Wednesday, September 21, 2022
PERMIT MODIFICATION APPROVAL
Horizontal 6A / New Drill

Re: Permit Modification Approval for VERNON JOHNSON WTZ 401H
47-103-03520-00-00

Well Bore Diagram updated

RE: Proposed Expedited Modification: Vernon Johnson WTZ 201H -103-03517
Vernon Johnson WTZ 401H -103-03520
Vernon Johnson WTZ ~~1H~~ - 103-03521
601H

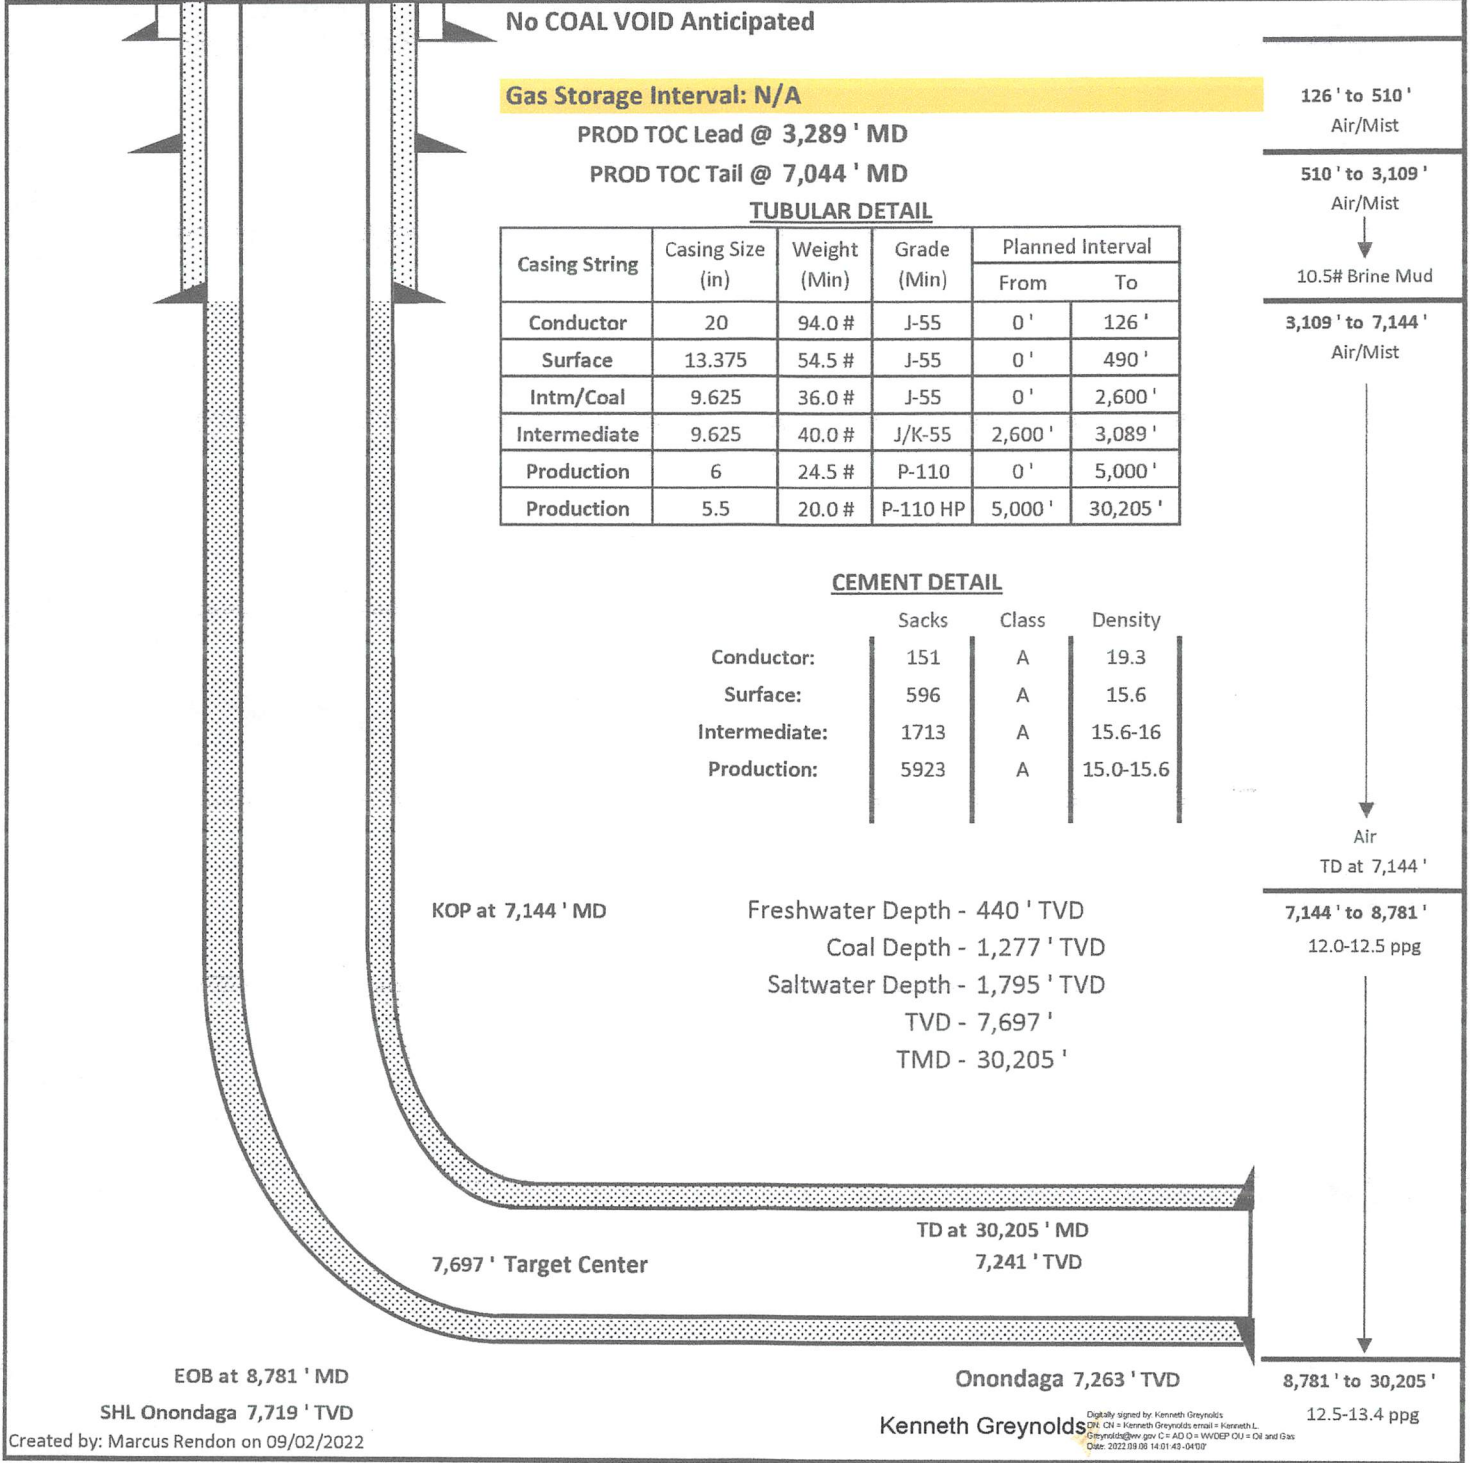
Enclosed please find the required documents to modify this well. We would like to modify this well from a gas storage zone to a none gas storage zone. This well is situated on the Johnson's property, in Clay District, Wetzel County, West Virginia.

Enclosed you will find:
-Updated WBD
